Re: Responses - Round 1

Plan Commission PC #23-010

Patton School Gym
1616 N. Patton Ave.
Arlington Heights, IL 60004

STR Project #22051

CX401

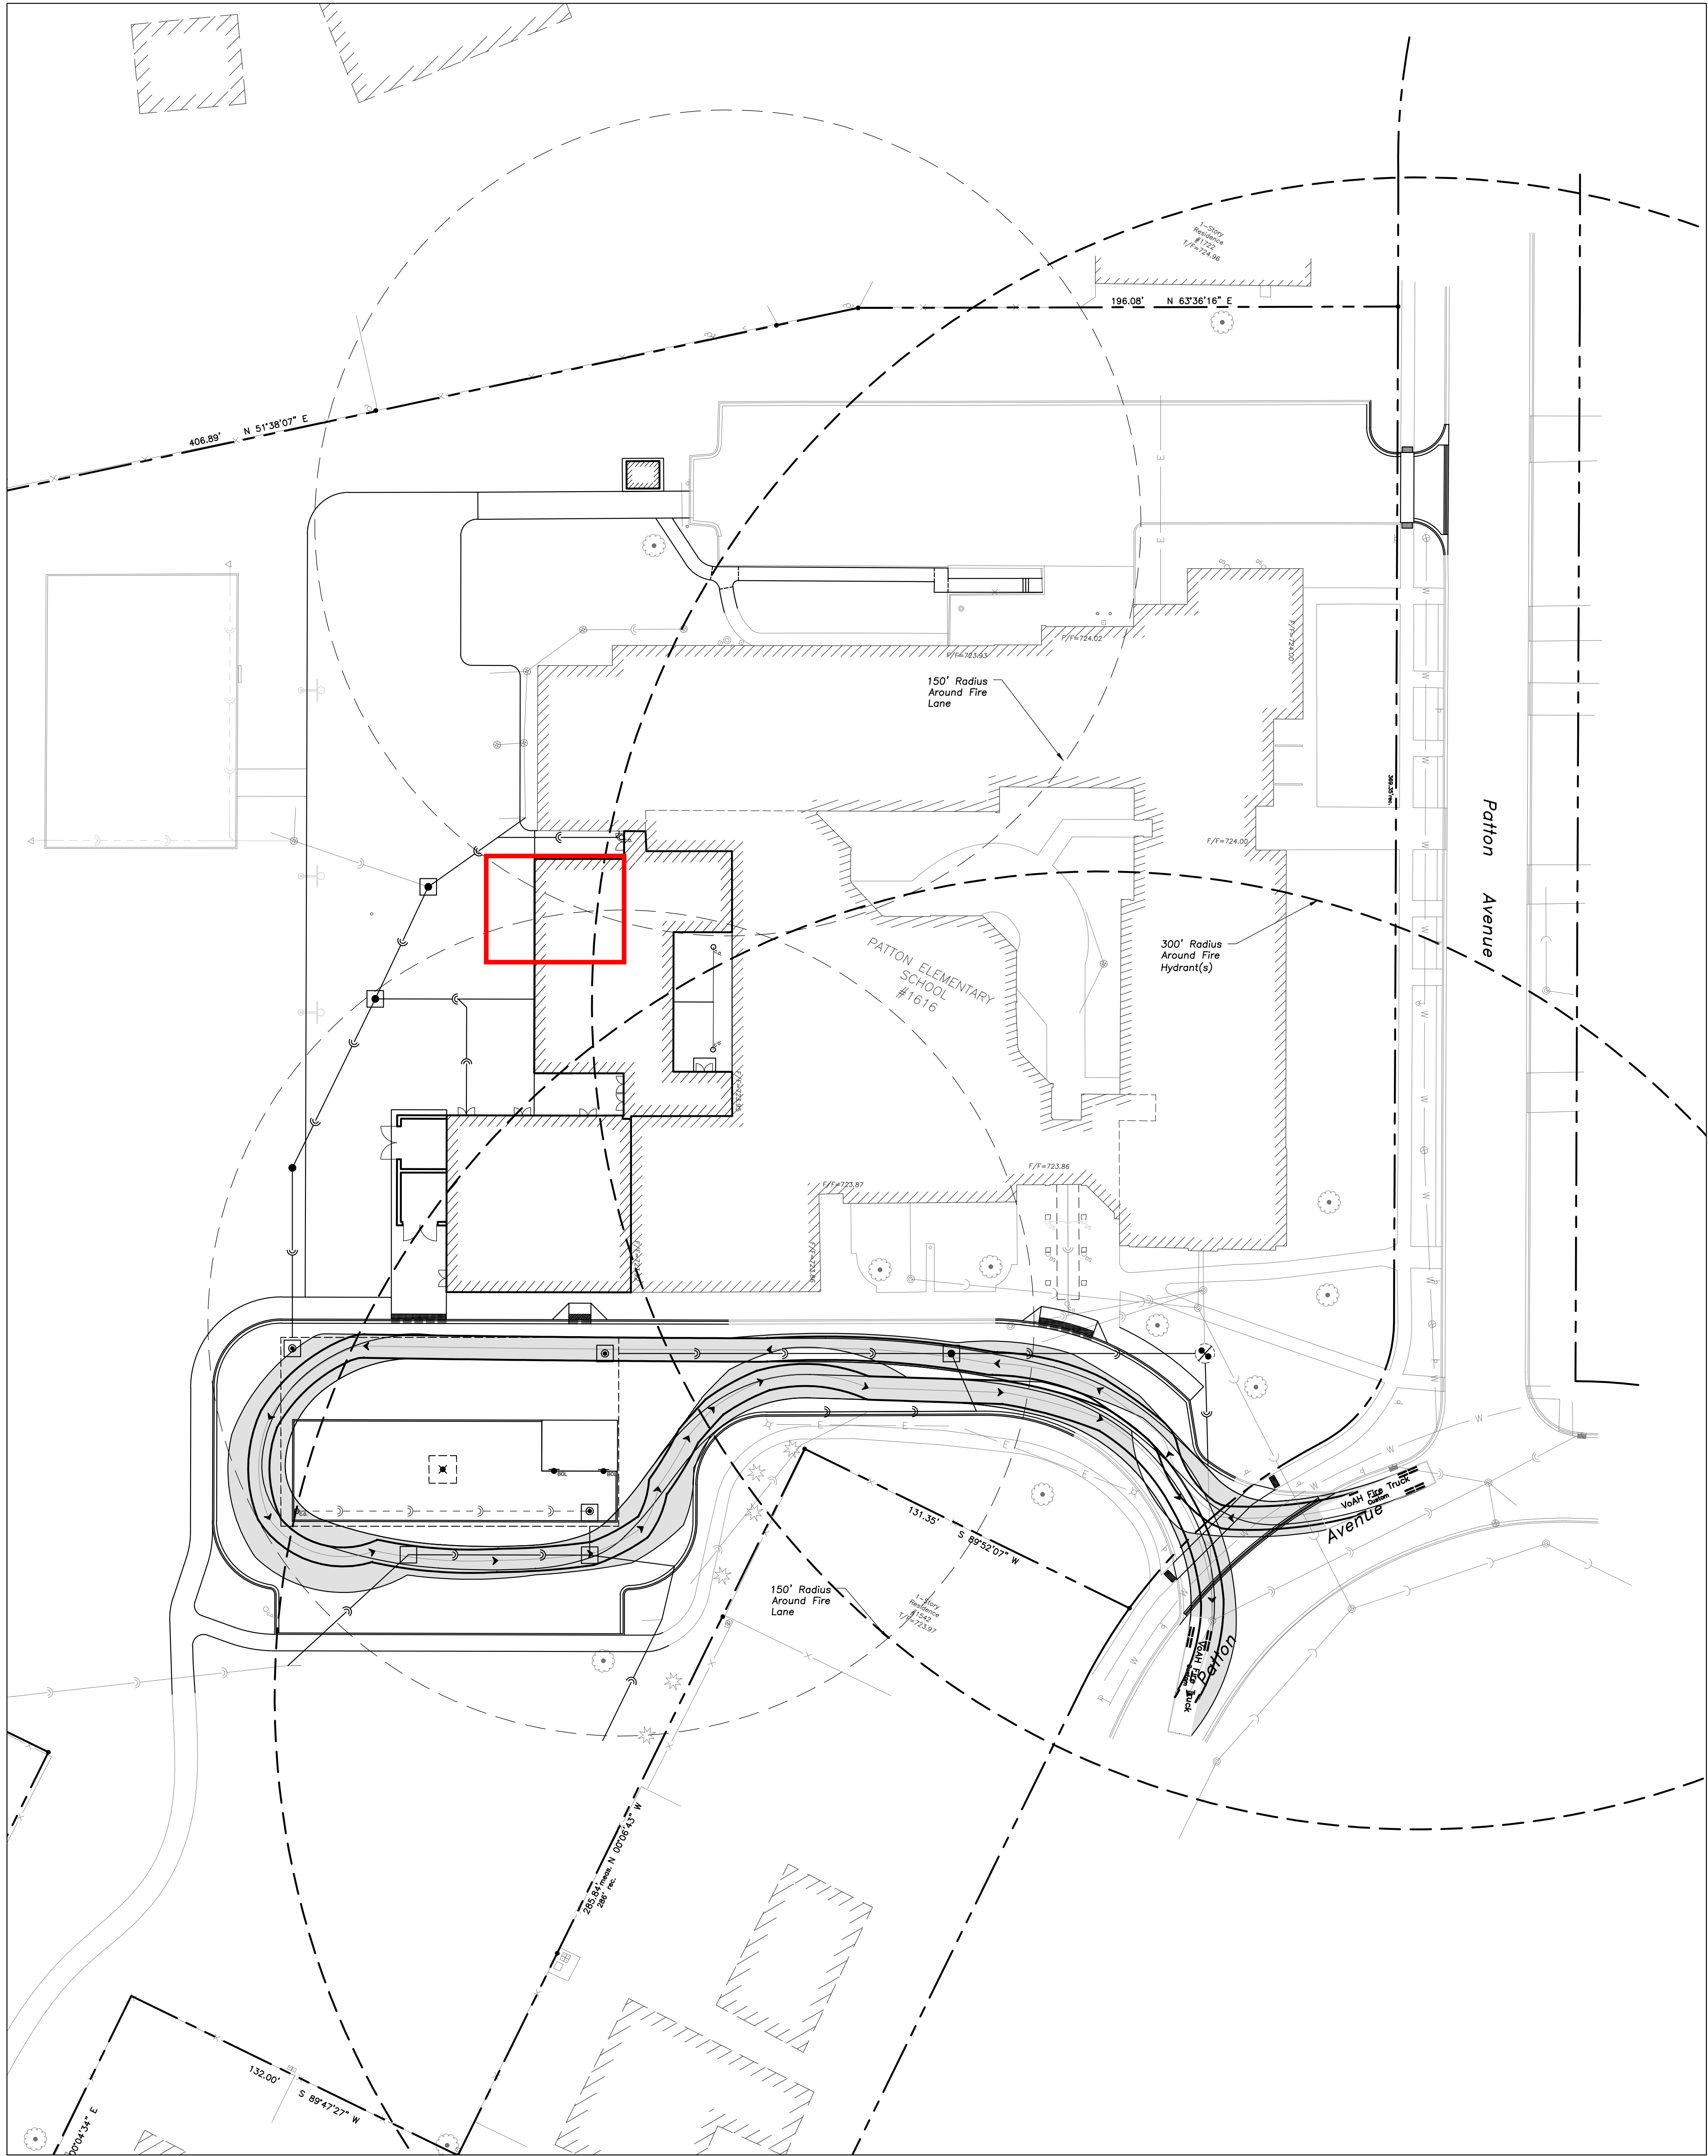
13. A fire lane previously existed to the west of the building, connecting the two parking lots. The fire lane was essentially eliminated with the repaving of the play area in 2019. The petitioner's engineer is in discussions with the Building & Life Safety Department on whether or not the fire lane should be reestablished. This can be addressed at permit.

Thanks again for your time for your time on the phone earlier. As discussed, I've attached an updated fire truck exhibit. The exhibit shows 300' radii from the nearest hydrants, and 150' radii from the approximate locations of an emergency response vehicle. I've indicated the small sliver of the building that is not fully covered by the 150' radii.

RESPONSE: Jorge Torres, CBO, Director, Building & Life Safety Department, commented "Approved, no fire lane will be required." via email on July 12, 2023 (attached). Attached is Fire Truck Exhibit CX401, dated 6/1/23, illustrating a 150' radii. If the radii is adjusted to 160', the building, and the proposed additions, are fully covered. Also attached is the "Building & Life Safety Department - Fire Apparatus Access Road Policy to Allow an Increase in Distance Where It May be Impossible/Impractical to Meet the Maximum Distance of 150 Feet" document. It should also be noted that the existing building and both of the proposed additions are/will be fully sprinkled in the final condition.

Approved, no additional fire lane will be required.

As discussed this morning, and with consideration given to the attached Fire Apparatus Access Road Policy and Fire Truck Exhibit, the maximum distance from the proposed fire apparatus access areas will not exceed 200 feet. The attached exhibit illustrates a 150' radii. If the radii is adjusted to 160', the building, and the proposed additions, area fully covered. It should also be noted that the existing building and both of the proposed additions are/will be fully sprinkled in the final condition.
